MEMORANDUM

TO: District of Columbia Board of Zoning Adjustment

FROM: Karen Thomas, Case Manager

SUBJECT: BZA Case 20615 - request for special exception relief to allow a two-story rear addition and two-story accessory garage to a semi-detached dwelling.

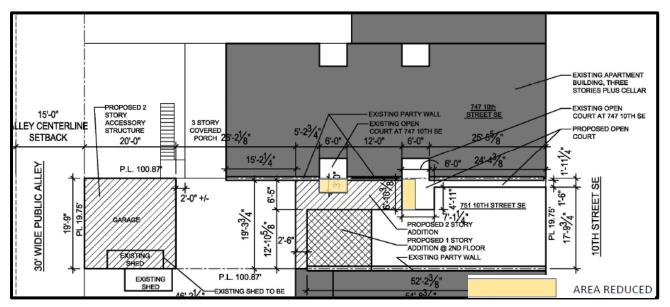
The proposed addition would expand the first and second floor levels of the existing twostory dwelling, increasing the lot occupancy from 42.3% to 68.3%. Initial plans (Exhibit 6) showed the proposed addition eliminating a portion of an existing 1.94-foot wide non-

conforming side yard. A portion of the side yard, with varying width of 1.94 feet to 6.8 feet, would extend from the front of the property to the addition at the property line (about 29 feet) (**Exhibit 2** – Plat reproduced here for ease of reference).

In response to concerns raised by the abutting owner of the apartment building to the north regarding the potential impact to light and air to units facing the courtyard, the applicant amended the application to propose a redesign submitted as **Exhibit 27** (reproduced plan in part) shown below:

This revision provides a 3-feet setback from the property line opposite a court on the neighboring building. This does not materially impact the side yard relief required but reduces the initial proposed lot occupancy from 69.9% to 68.3%.
